Morgantown Planning Commission

- IV. **OLD BUSINESS** – None
- V. **NEW BUSINESS**
 - A. **S14-01-III / CA Student Living / 494 Spruce Street:** Request by Lisa Mardis of Project Management Services, on behalf of CA Student Living, for Development of Significant Impact Type III Site Plan approval of a mixed-use development at 494 Spruce Street; Tax Map 26, Parcels 245 and 246; B-4, General Business District.

Request by Lisa Mardis of Project Management Services, on behalf of CA Student Living, for Development of Significant Impact Type III Site Plan approval of a mixed-use development at 494 Spruce Street

**PLANNING AND ZONING CODE CONFORMITY REPORT
FOR REVISED PLANS SUBMITTED 25 APR 2014**

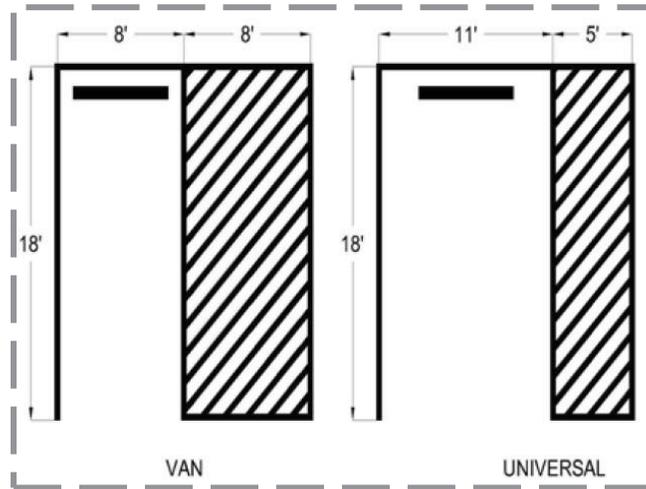
- (1) Concerning “Curb Cut” standards provided under Article 1351.01(D), agreement on the points of tangency for the driveway flares must be achieved so that the extent of requisite variance relief, as currently designed, can be identified.

As discussed with Mr. Carl Emberger this day, modification of the driveway “flares” to meet the maximum 26-foot standard provided under Article 1351.01(D) would eliminate variance relief in terms of width and in terms of proximity to the Spruce – Willey intersection. The City Engineer’s Office has agreed to model and compare the proposed design and the Article 1351.01(D) standards and advise the undersigned and the project’s design professionals accordingly. However, a final decision from the project’s design team is necessary on whether the presently designed driveway “flares” will be pursued or modified to conform with related standards.

Regardless of whether the present design or modified conforming design is pursued, please submit an inset drawing or separate sheet (hard copy) to this office no later than FRI 25 APR 2014 that identifies and labels the relational dimensions and distances between “true” points of tangency and the five (5) performance standards provided under Article 1351.01(D).

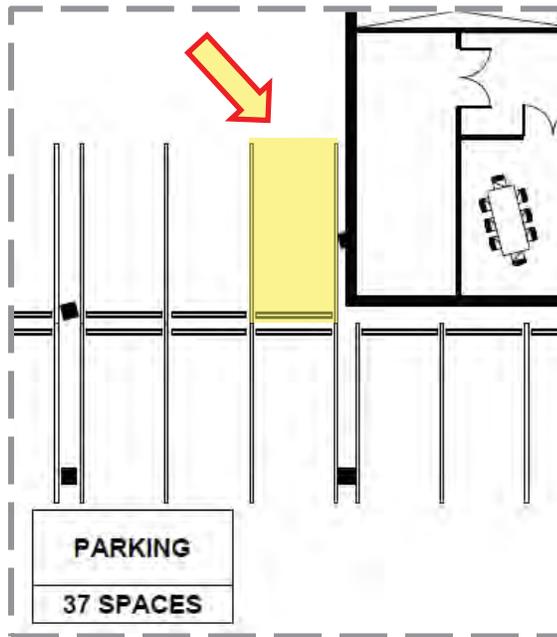
- (5) The following graphic is clipped from Sheet Z0.02 illustrating a portion of the Level 01 Floor Plan. The parking space highlighted in yellow should be designed and managed as a compact space to ensure sufficient depth for maneuvering.

- (6) Motorcycle design standards in Article 1329.02 provide for a minimum of four (4) feet wide and a minimum of nine (9) feet deep, which appears to have been provided on Level 01 as illustrated on Sheet Z0.02 (see clipped graphic below). However, the angles of said motorcycle parking spaces should be modified slightly to ease maneuvering for all spaces given the locations of structural columns; provided the drive aisle is not obstructed.

PROJ. NO.: 1310125.01
 DATE: 04/25/2014
 SHEET NO.: 5

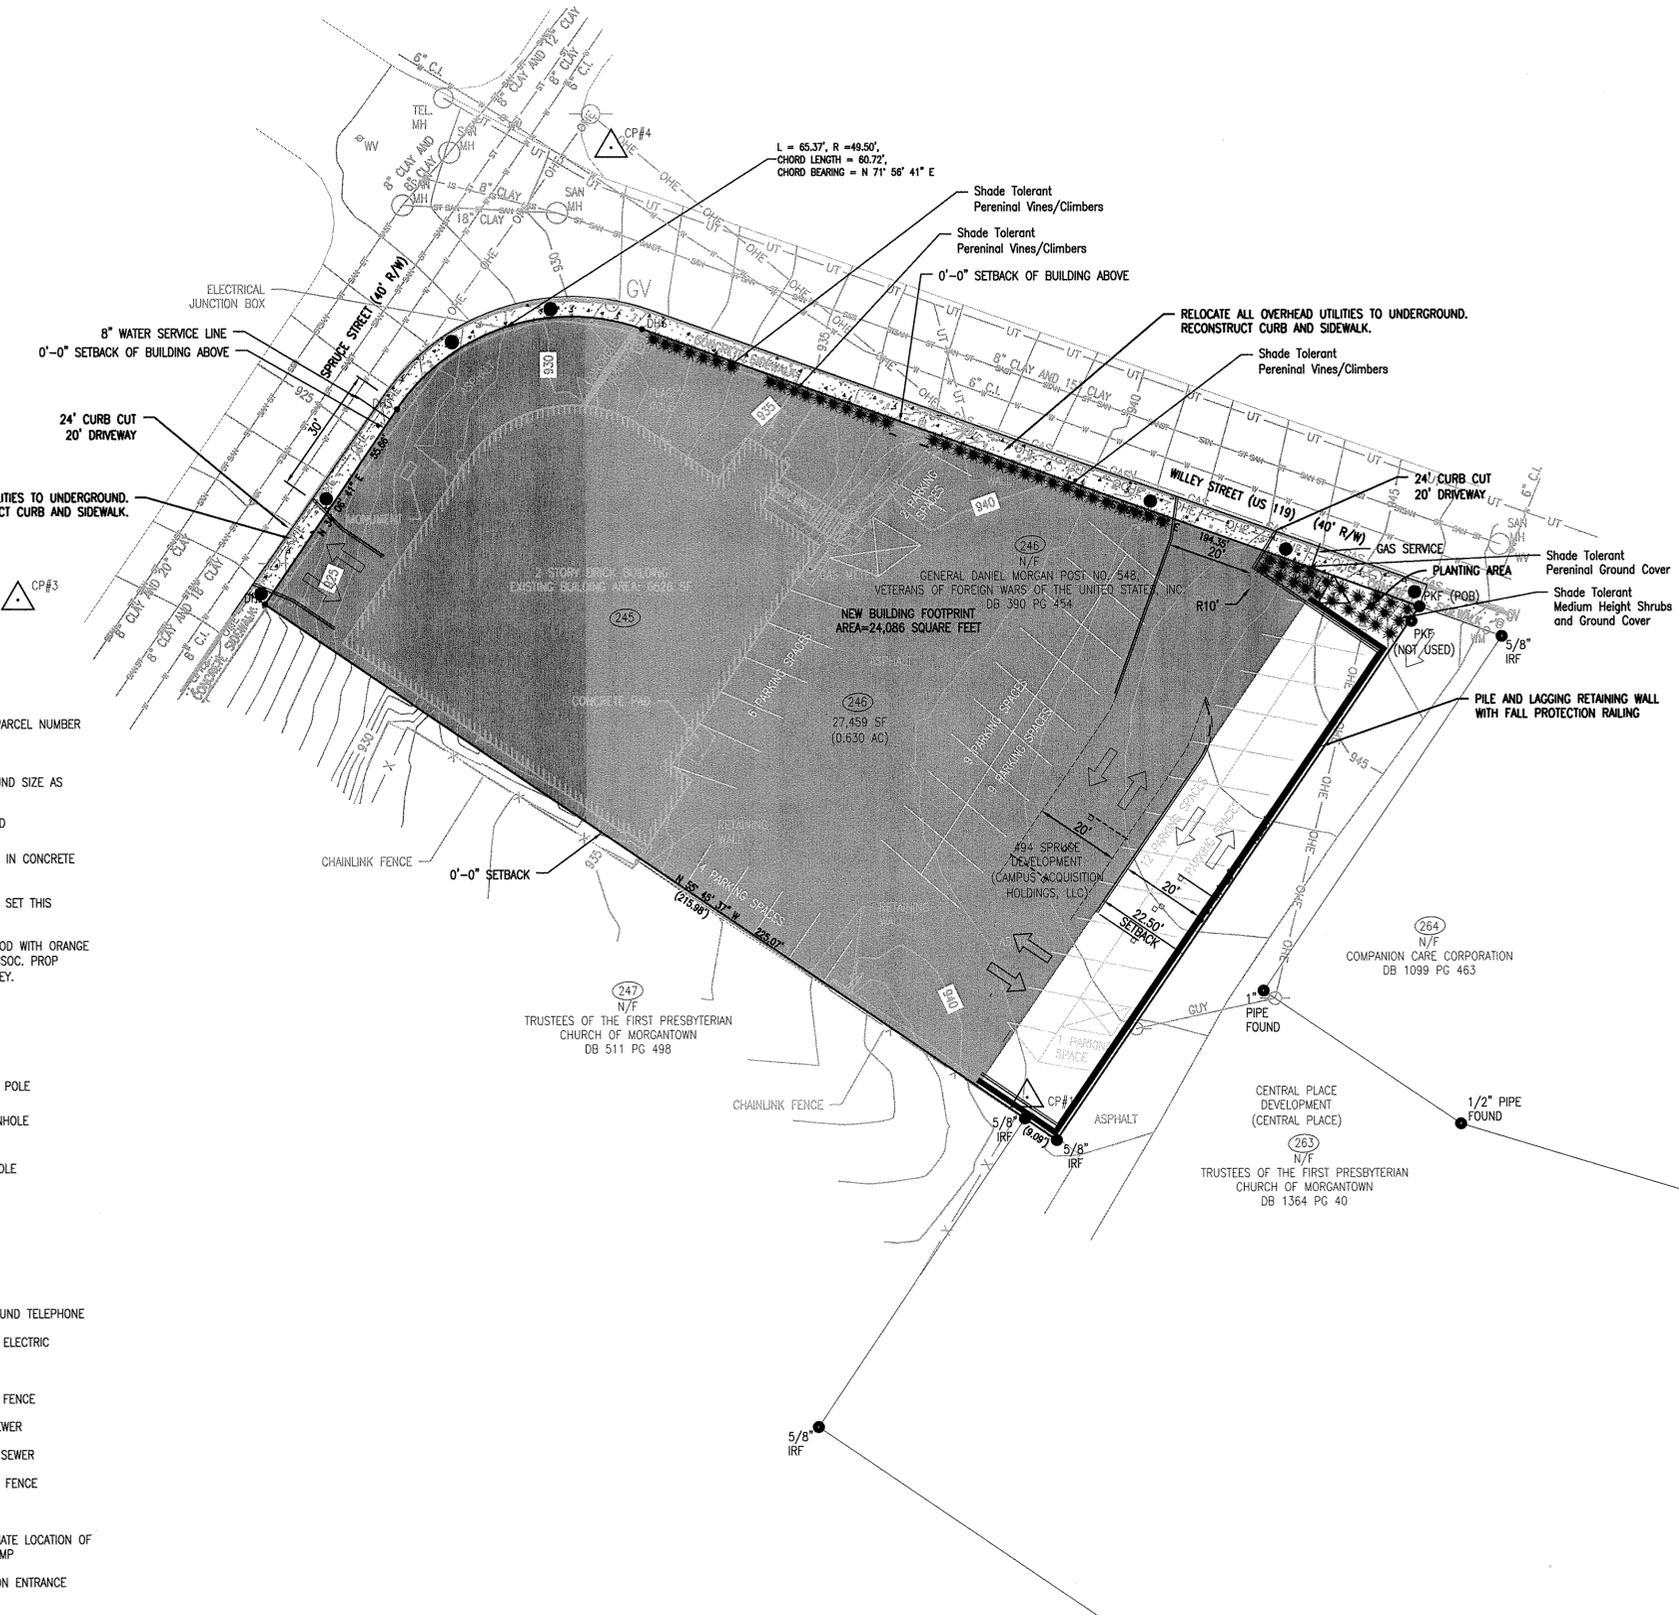
1367 Landscaping and Screening	
TBD	Sheet 5 illustrates proposed landscape areas. Staff understands that project's landscape design professional, RoofMeadow, is researching appropriate green-screen and shade tolerant shrubs and ground cover that will be identified in building permit application plans.

- (2) Sheets 3B, 4, and 5 of the drawings prepared by Alpha Associates appear to include a structural ramp and below grade parking on the P1 level. The undersigned understands that these elements are from a previous design iteration and have since been removed as illustrated on the emArchitecture drawings reviewed herein. Said Alpha Associates sheets must be revised to coincide with the emArchitecture drawings and hard copies submitted to this office no later than FRI 25 APR 2014.
